V2500-A1/A5 PROPULSION SYSTEMS SERVICE BULLETIN

This document transmits the Initial Issue of Service Bulletin EV2500-73-0166 and the Initial Issue of the Supplement

ENGINE FUEL AND CONTROL – FUEL SYSTEM AIR TUBES – INTRODUCTION OF NON-VENTED BURNER
TO EEC PRESSURE (PB) SENSE LINE TUBE ASSEMBLIES

Family Tree
Fig.1

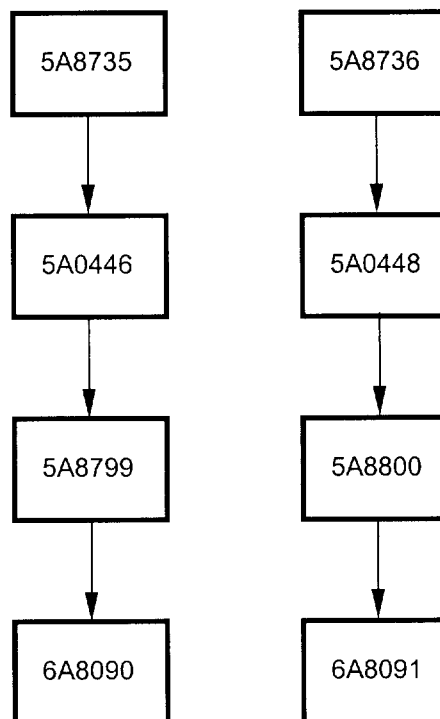
Fuel and Control - Rework the PS3 burner air tube assembly to incorporate enlarged moisture trap drain holes.

Fuel and Control - Incorporate burner pressure (Pb) sensor tubes with revised holes.

Engine Fuel and Control - Fuel System Air Tubes - Introduction of non-vented burner to EEC pressure (Pb) sense line tube assemblies.

Family Tree
Fig.2

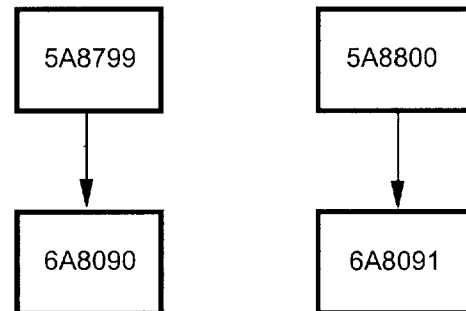
Engine Fuel and Control - Fuel System Air Tubes -
Introduction of non-vented burner to EEC pressure (Pb)
sense line tube assemblies.
